গণপ্রজাতন্ত্রী বাংলাদেশ সরকার
শ্রম ও কর্মসংস্থান মন্ত্রণালয়
কলকারখানা ও প্রতিষ্ঠান পরিদর্শন অধিদপ্তর

ক্যাপ পর্যবেক্ষণের তথ্য

কারখানার নাম	মেসার্স কাট এন সিউ লিঃ
ঠিকানা	A. M. Plaza (10Th Floor), 76, DIT Road
কারখানার কোড	DHK145
কালার কোড

মূল্যায়নের ধরণ: বৈদ্যুতিক মূল্যায়ন	পর্যবেক্ষণের তারিখ: ০৫-০৪-২০২৩
১. পর্যবেক্ষণ

সংযুক্তিসমূহ (৪)

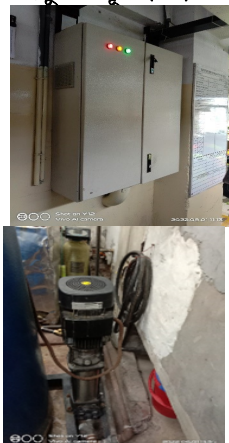
পরিদর্শন পর্যবেক্ষণ	<input type="checkbox"/> Access to substation not easy <input type="checkbox"/> Ventilation and illumination of substation is poor <input type="checkbox"/> Separating wall not extended up to the ceiling <input type="checkbox"/> No SLD/clear identification mark on distribution panel <input type="checkbox"/> No instruction for first aid to electrical shock and artificial respiration <input type="checkbox"/> Non-conductor mat not provided/ insufficient <input type="checkbox"/> Improper earthing <input type="checkbox"/> Loose or temporary cabling/connection without lug/uncovered cable trench <input type="checkbox"/> lint/dirt in substation
কাপ আইটেম ক্যাটাগরি

কার্যক্রম	<input type="checkbox"/> Keep the substation clean <input type="checkbox"/> Provide instructions for first aid and artificial respiration from exposure to electrical shock. <input type="checkbox"/> Provide cover on the cable trench and rubber mat in front of the panel <input type="checkbox"/> Ensure well-dressed cabling with lugs
সুপারিশের ভিত্তিসূত্র	
কারখানার কার্যক্রম	They have taken some action and they have agreed to complete within the timeline.
অগ্রাধিকার	প্রয়োজ্য নয়
চূড়ান্ত সময়সীমা	০৫-১০-২০১৬
সংশোধিত সময়সীমা	০১-০১-১৯৭০
অগ্রগতির অবস্থা	চলমান
মন্তব্য	<p>24-07-2018: 1. Substation have been found clean. 2. First aid and electric shock recuperation instruction were not provided at required areas. 3. Cable trenches were not covered properly in substation room. 4. Rubber mat needs to be provided in required places. 23-10-2018: Same as above observation. 17-04-2019: Same as above observation. 18-12-2019: 1. Substation was found clean. 2. First aid and electric shock recuperation instruction were not provided near some distribution boards. 3. Cable trenches were found to be covered and proper rubber mats were found in front of the panel boards. 4. Cables were not found to be well dressed in some panel boards and proper cable lugs were not used for termination in MCB. 19-08-2020: Same as above. 09-11-2020 1. Substation was found clean. 2. First aid and electric shock recuperation instruction were provided near some distribution boards. 3. Cable trenches were found to be covered and proper rubber mats were found in front of the panel boards. 4. Cables were found to be well dressed in some panel boards and proper cable lugs were used for termination in MCB. 09-02-2021 Visit Observation : 1. Substation was found clean. 2. First aid and electric shock recuperation instruction were provided near some distribution boards. 3. Cable trenches were found to be covered and proper rubber mats were found in front of the panel boards. 4. Cables were found to be well dressed in panel boards and proper cable lugs were used for termination in MCB. 09-05-2021 Visit Observation : 1. Substation was found clean. 2. First aid and electric shock recuperation instruction were provided near some distribution boards. 3. Cable trenches were found to be covered and proper rubber mats were found in front of the panel boards. 4. Cables were found to be well dressed in panel boards and proper cable lugs were used for termination in MCB. 10/08/2021: Substation room is found to be clean. Instruction for first aid and artificial respiration from exposure is provided. Rubber mat is not provided in front of the LT panel. Well dressed cabling with lugs is ensured. 01-08-2022 Visit Observation : 1. Substation room was not found clean during inspection period. 2. Instruction for first aid and artificial respiration was not found for every panel board. 3. Rubber mat is not provided in front of the LT panel. 4. Well dressed cabling with lugs is not ensured. 05.04.2023: 1. Substation room was not found clean during inspection period. 2. Instruction for first aid and artificial respiration was not found for every panel board. 3. Rubber mat is not provided in front of the LT panel. 4. Well dressed cabling with lugs is not ensured.</p>

সংযুক্তিসমূহ (৬)

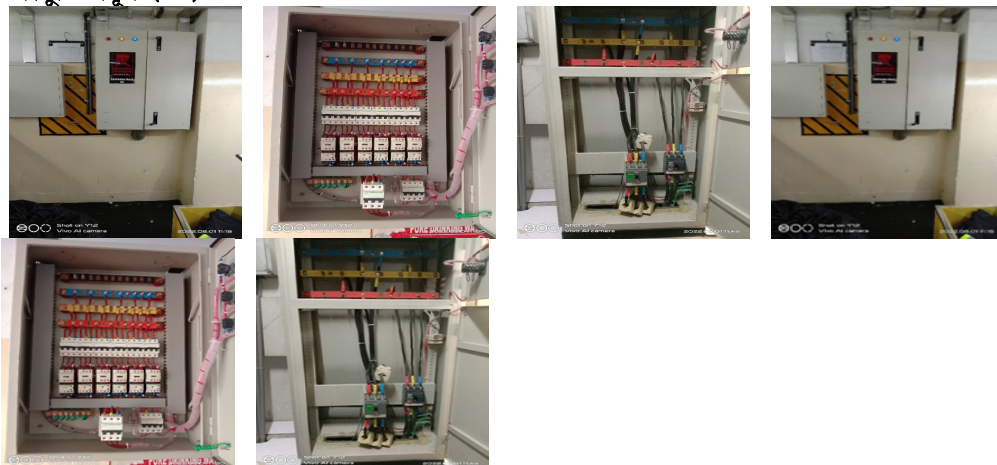
পরিদর্শন পর্যবেক্ষণ	<input type="checkbox"/> No instruction for first aid to electrical shock <input type="checkbox"/> Access obstructed/barred <input type="checkbox"/> Connections without lug <input type="checkbox"/> Body & door not earthed <input type="checkbox"/> No SLD/clear identification mark for distribution board <input type="checkbox"/> MDB/SDB/SB or MCB installed on the wooden board <input type="checkbox"/> Live parts of machine or equipment exposed <input type="checkbox"/> Motor frame not earthed
ক্যাপ আইটেম ক্যাটাগরি

কার্যক্রম	<input type="checkbox"/> Provide instructions for first aid for exposure to electrical shock <input type="checkbox"/> Remove obstruction to ensure access to MDB/MCB Box <input type="checkbox"/> Ensure well-dressed cabling with lugs <input type="checkbox"/> Cover the exposed live parts.
সুপারিশের তথ্যসূত্র	
কারখানার কার্যক্রম	It has been implemented.
অগ্রাধিকার	প্রযোজ্য নয়
চূড়ান্ত সময়সীমা	-
সংশোধিত সময়সীমা	০১-০১-১৯৭০
অগ্রগতির অবস্থা	চলমান
মন্তব্য	<p>24-07-2018: 1. First aid and electric shock recuperation instruction were not provided at required area. 2. Cables are not well dressed in some panel boards. 3. Live part are not covered properly in some machine. 4. Motor frame are earthed but dedicated earthing for each circuit breaker is required. 23-10-2018: Same as above observation. 17-04-2019: Same as above observation. 18-12-2019: 1. First aid electric shock recuperation were found near some distribution boards. 2. Clearance for distribution boards and MCB box were not found. Needs minimum 1m clearance around according to NTPA guideline. 3. Cables were not found to be well dressed in some panel boards and proper cable lugs were not used for termination in MCB. 4. MCB box were found to be without cover. 19-08-2020: 1. Same as above. 2. Clearance for distribution boards and MCB box were found. 3. Same as above. 4. MCB box were not found to be without cover. 09-11-2020: 1. First aid electric shock recuperation were found near some distribution boards. 2. Clearance for distribution boards and MCB box were found. 3. Cables were found to be well dressed in some panel boards and proper cable lugs were used for termination in MCB. 4. MCB box were not found to be without cover. 09-05-2021 Visit Observation : 1. First aid electric shock recuperation were found near some distribution boards. 2. Clearance for distribution boards and MCB box were found. 3. Cables were found to be well dressed in some panel boards and proper cable lugs were used for termination in MCB. 4. MCB box were not found to be without cover. 09-02-2021 Visit Observation : 1. First aid electric shock recuperation were found near some distribution boards. 2. Clearance for distribution boards and MCB box were found. 3. Cables were found to be well dressed in some panel boards and proper cable lugs were used for termination in MCB. 4. MCB box were not found to be without cover. 10/08/2021: Instruction for first aid to electrical shock has been provided for all the distribution boards. Access to MDB/MCB box has been ensured. Well dressed cabling with lugs has been ensured inside all the distribution boards. Exposed live parts are not covered. 01-08-2022 Visit Observation : 1. Instruction for first aid to electrical shock and artificial respiration was not found for every panel board. 2. Access to MDB/MCB box has been ensured. 3. Well dressed cabling with lugs has not been ensured inside all the distribution boards. 4. Exposed live parts are not covered. 05.04.2023: 1. Instruction for first aid to electrical shock and artificial respiration was not found for every panel board. 2. Access to MDB/MCB box has been ensured. 3. Well dressed cabling with lugs has not been ensured inside all the distribution boards. 4. Exposed live parts are not covered.</p>
